Charlotte-Mecklenburg Planning, Design, & Development

SUBJECT: Administrative Approval for Petition No. 2020-035 CCP University, LLC

ADMINISTRATIVE AMENDMENT # RZAAMA-2021-00044

CHARLOTTE, NC REZONING #2020-035

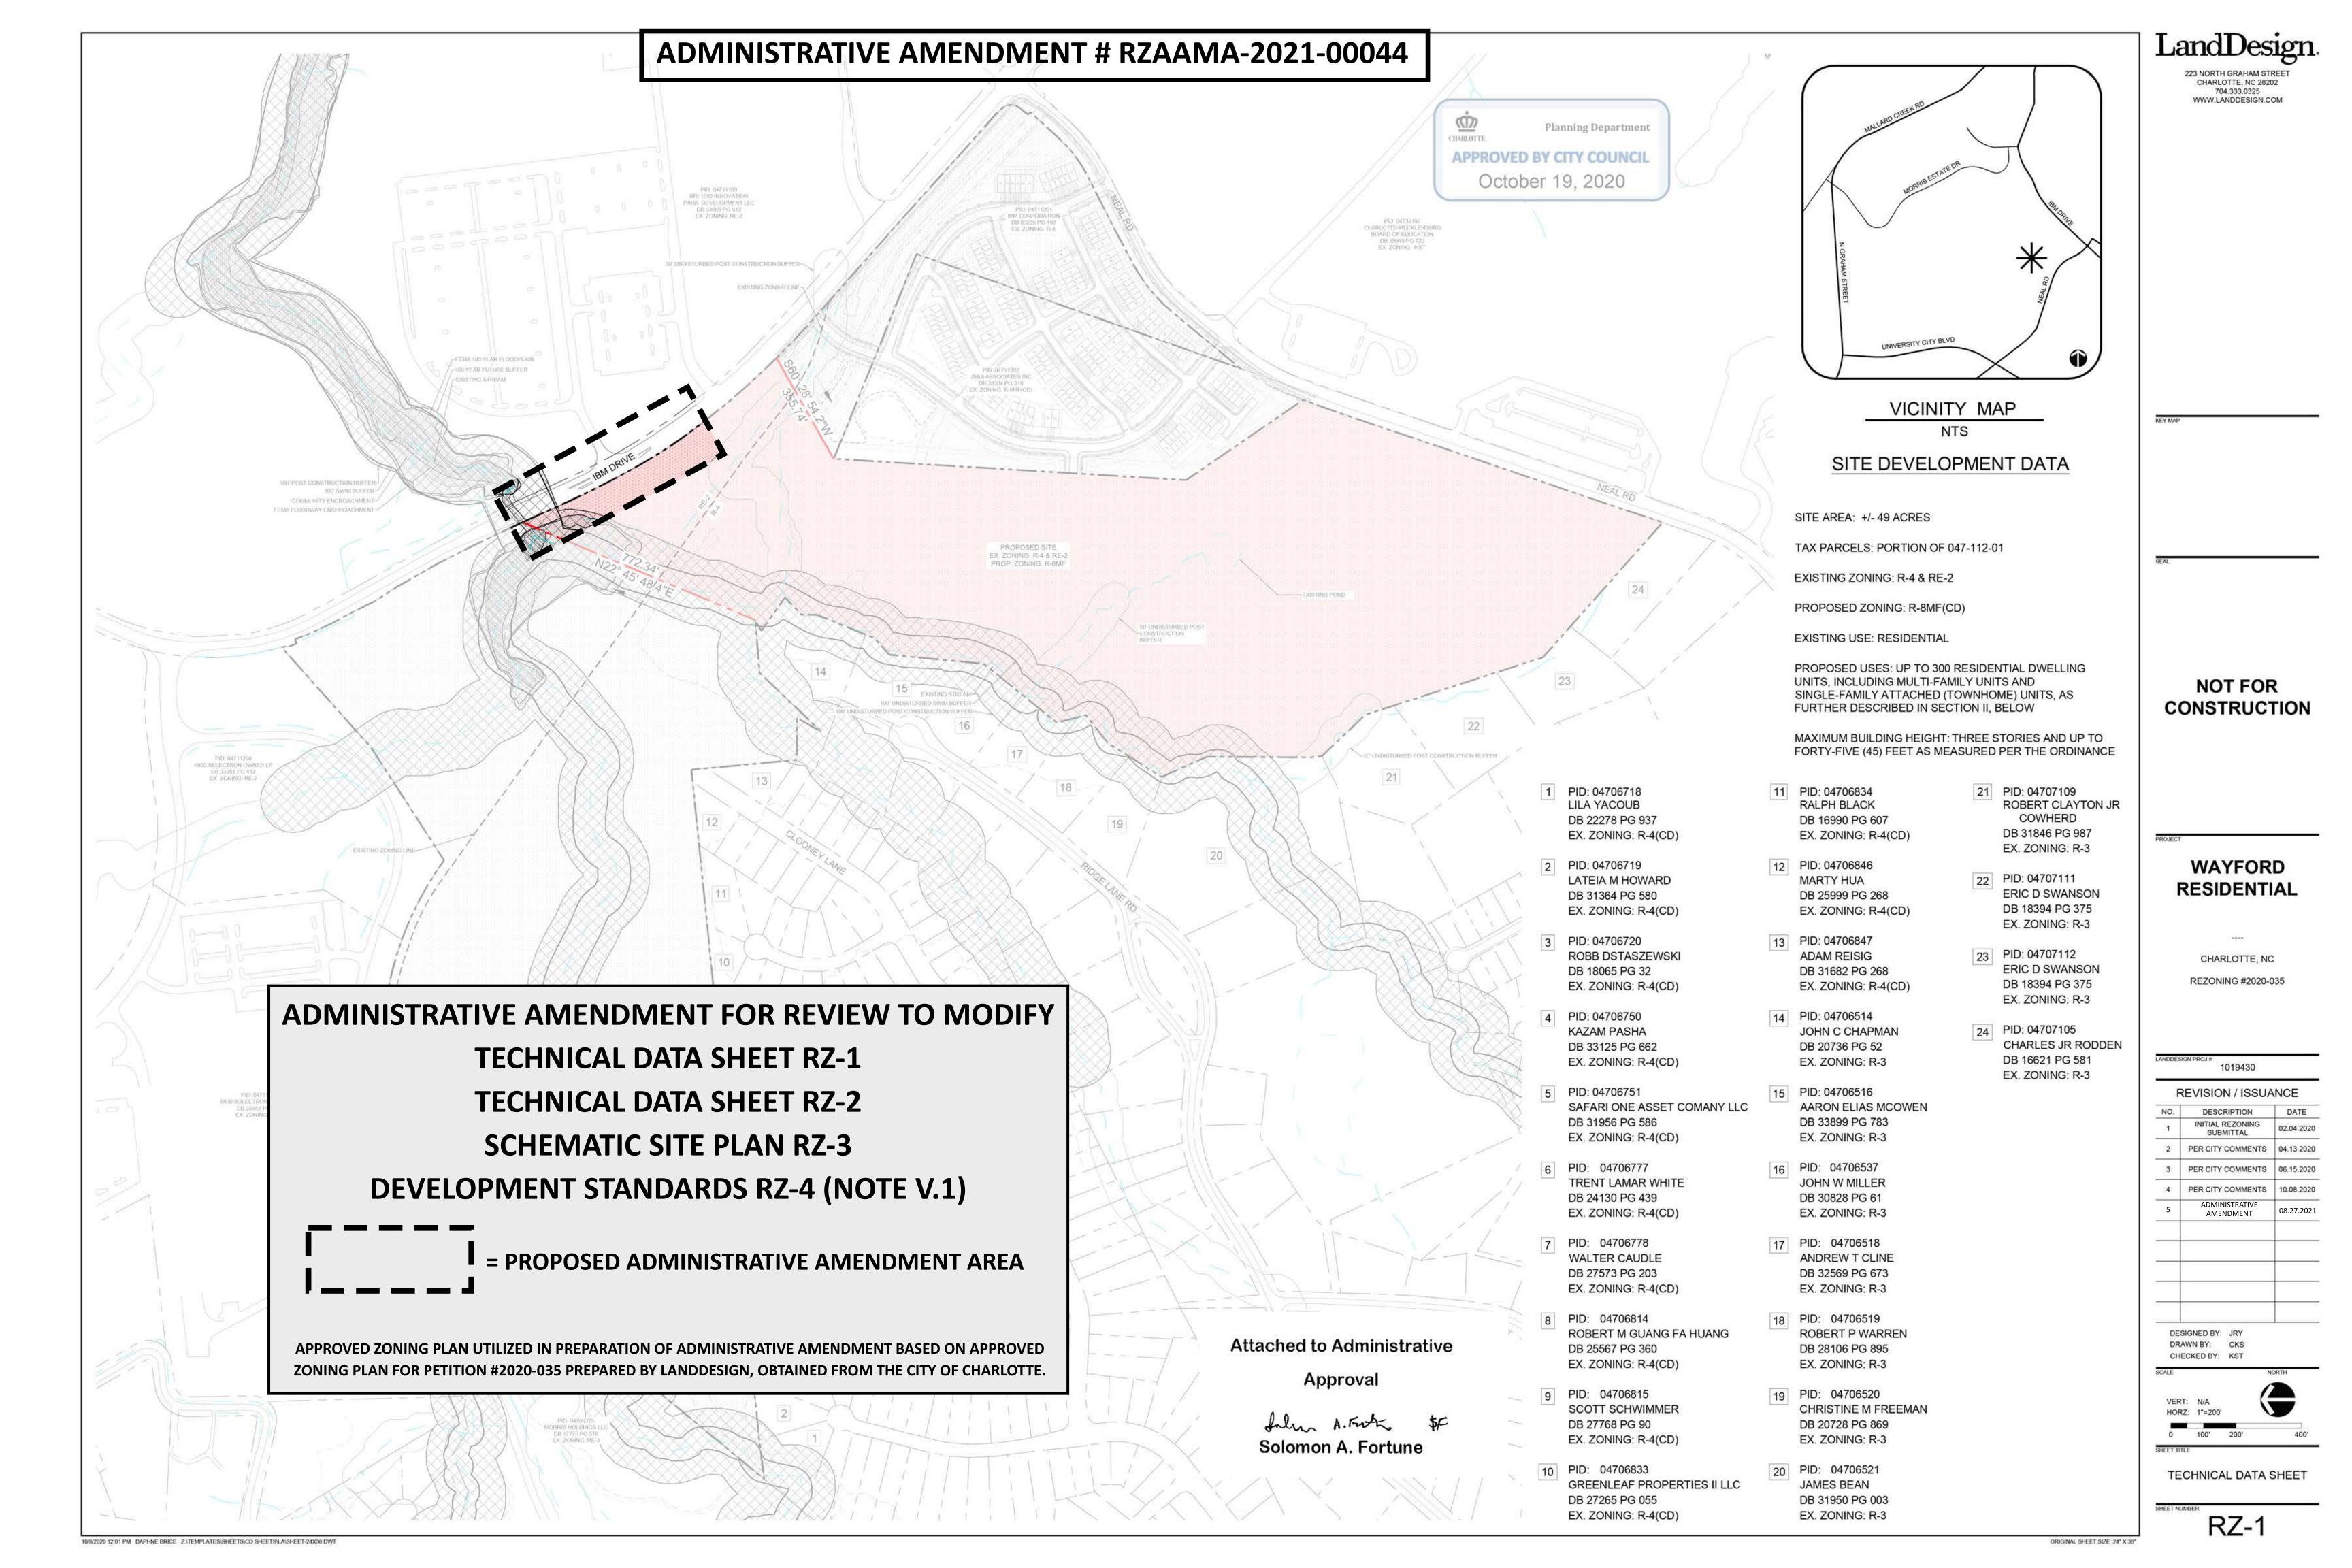
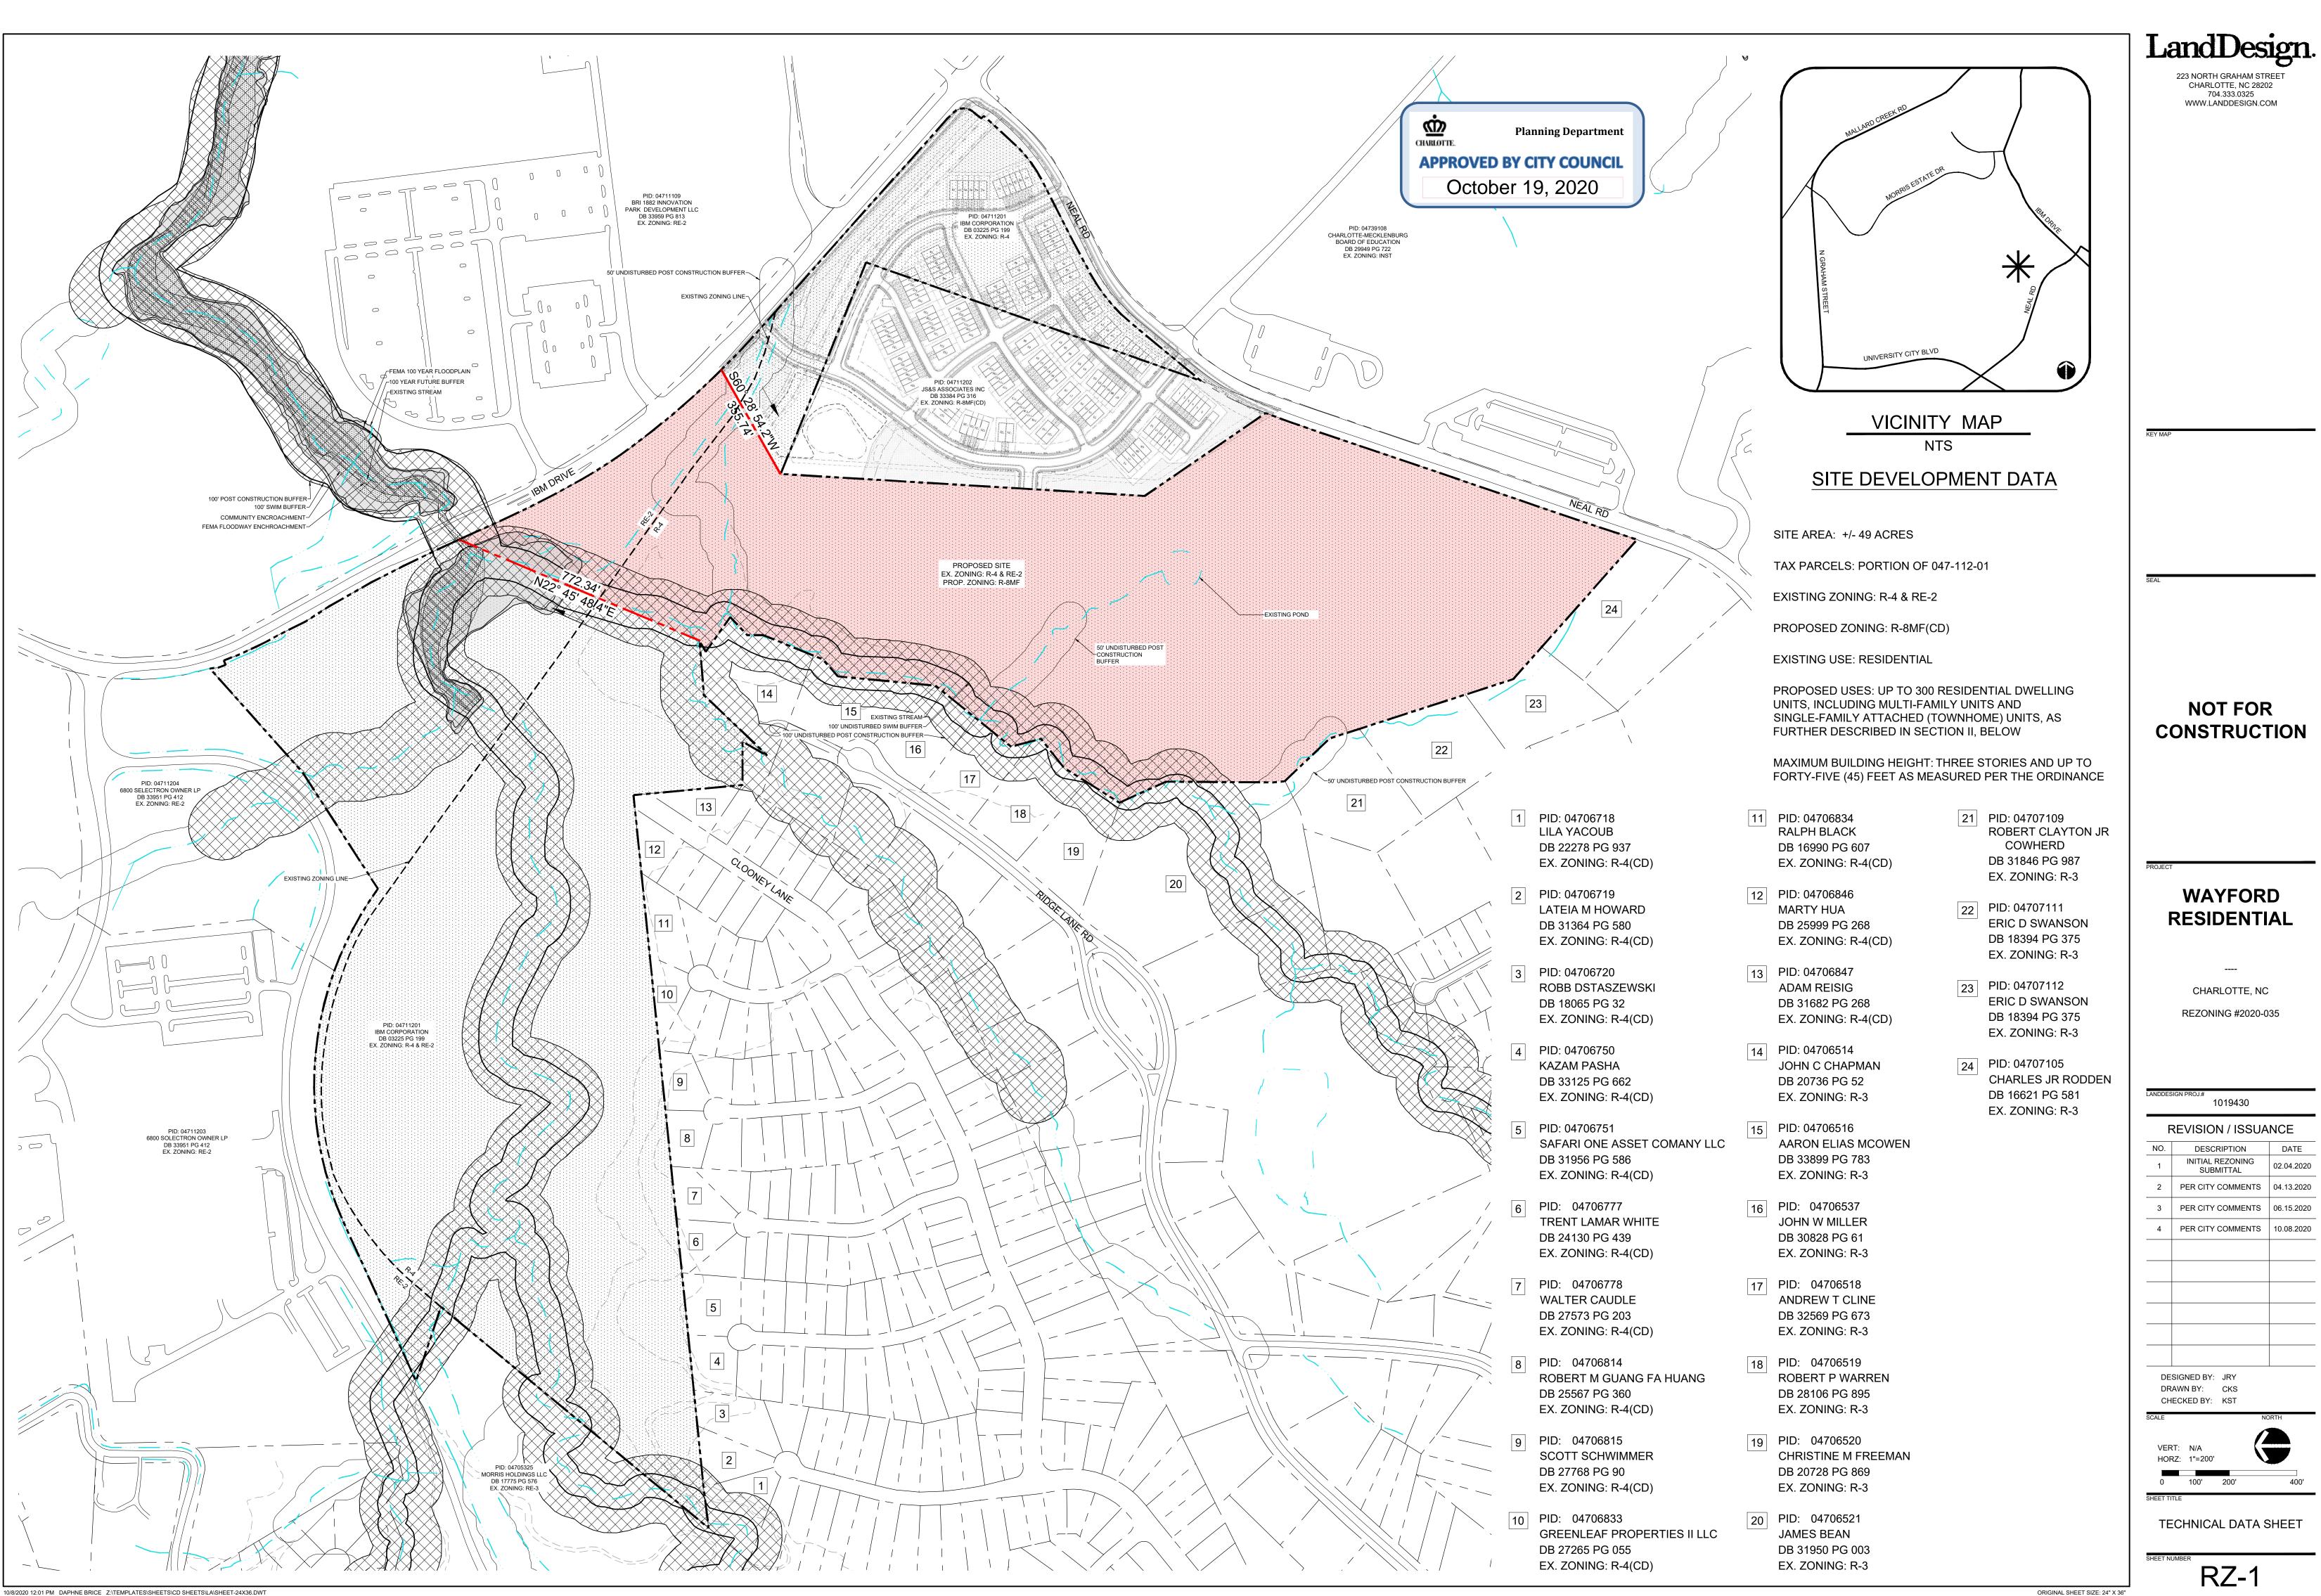
• Modification to the proposed streetscape and sidewalk along a portion of IBM Drive.

. THE PETITIONER SHALL CONSTRUCT A MINIMUM SIX (6) FOOT SIDEWALK AND EIGHT (8) FOOT WIDE PLANTING STRIP ALONG THE SITE'S INTERNAL PUBLIC STREETS. THE PETITIONER SHALL CONSTRUCT A MINIMUM SIX (6) FOOT SIDEWALK AND EIGHT (8) FOOT WIDE PLANTING STRIP ALONG THE SITE'S FRONTAGE WITH IBM DRIVE EXCEPT WHERE SITE CONDITIONS, INCLUDING DRAINAGE AND TOPOGRAPHY, DO NOT PERMIT AS INDICATED IN THE ADMINISTRATIVE AMENDMENT. WHERE THESE CONDITIONS EXIST, THE PETITIONER MAY CONSTRUCT A SIX (6) FOOT WIDE SIDEWALK AT THE BACK OF CURB ON THE SITE'S FRONTAGE WITH IBM DRIVE, AS GENERALLY DEPICTED IN THE ADMINISTRATIVE AMENDMENT. THE PETITIONER SHALL PROVIDE A MINIMUM TWELVE (12) FOOT WIDE SIDEWALK AND EIGHT (8) FOOT WIDE PLANTING STRIP ALONG THE SITE'S FRONTAGE OF NEAL ROAD, PER SECTION III.5. ABOVE.
